UNITED STATES
DEPARTMENT OF THE INTERIOR
BUREAU OF LAND MANAGEMENT
APPLICATION FOR PERMIT TO DRILL OR REENTER

1a. Type of work: <input checked="" type="checkbox"/> DRILL <input type="checkbox"/> REENTER 1b. Type of Well: <input checked="" type="checkbox"/> Oil Well <input type="checkbox"/> Gas Well <input type="checkbox"/> Other 1c. Type of Completion: <input type="checkbox"/> Hydraulic Fracturing <input checked="" type="checkbox"/> Single Zone <input type="checkbox"/> Multiple Zone		5. Lease Serial No. NMNM102917 6. If Indian, Allottee or Tribe Name 7. If Unit or CA Agreement, Name and No. 8. Lease Name and Well No. CASEY JONES 21 FED COM 708H 9. API Well No. 30-015-54122

PECOS DISTRICT DRILLING CONDITIONS OF APPROVAL

OPERATOR'S NAME:	EOG RESOURCES INCORPORATED
WELL NAME & NO.:	CASEY JONES 21 FED COM 708H
SURFACE HOLE FOOTAGE:	2466'/N & 2392'/W
BOTTOM HOLE FOOTAGE:	230'/N & 2630'/E
LOCATION:	Section 21, T.26 S., R.30 E., NMP
COUNTY:	Eddy County, New Mexico

Proposed Wellbore

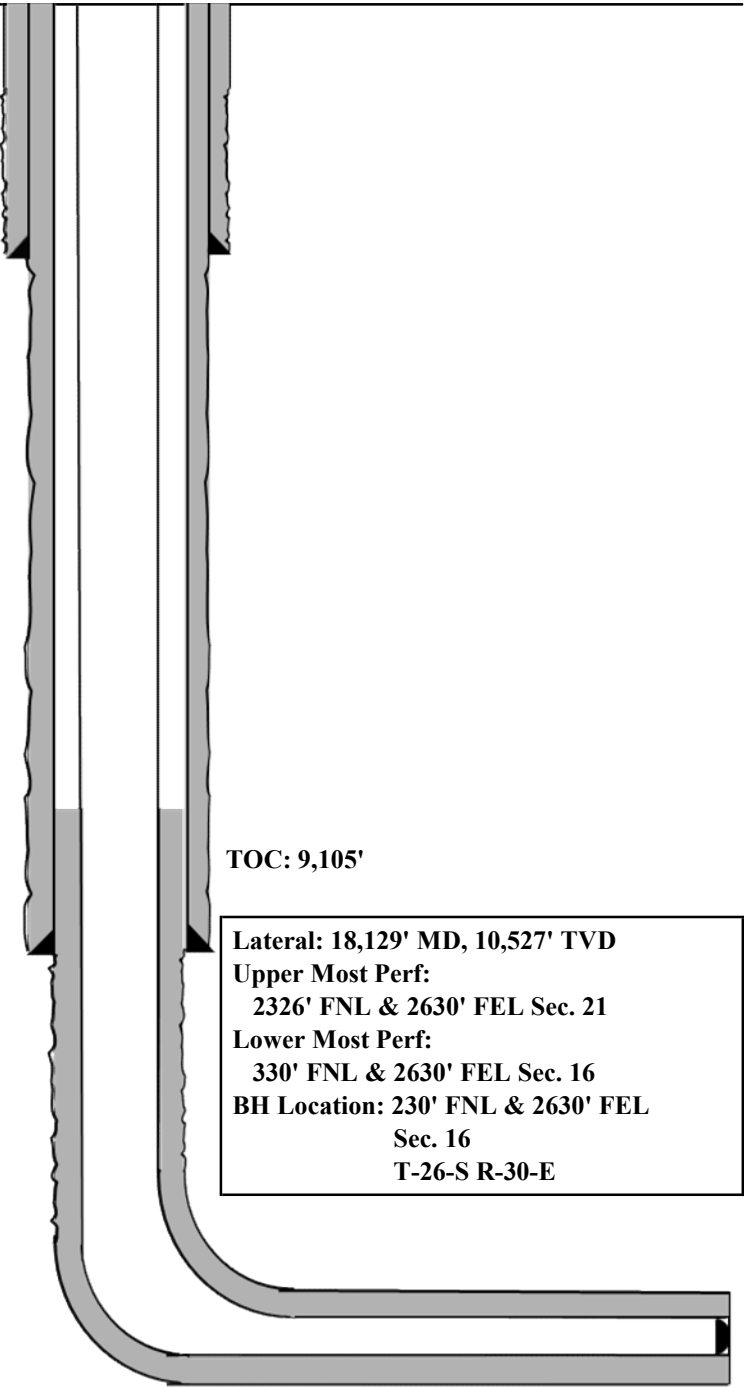
Operator is only approved for Design A. Design B is not to be utilized. If Design B is needed or any other change, please submit a NOI sundry to make the changes.

Operator has proposed to pump down 9-5/8" X 7-5/8" annulus after primary cementing stage. Operator must run Echo-meter to verify Cement Slurry/Fluid top in the annulus Or operator shall run a CBL from TD of the 7-5/8" casing to surface after the second stage BH to verify TOC.

3. The minimum required fill of cement behind the **5-1/2** inch production casing is:
 - Cement should tie-back at least **200 feet** into previous casing string due to operator not meeting casing clearance requirement per 43 CFR 3170. Operator shall provide method of verification.
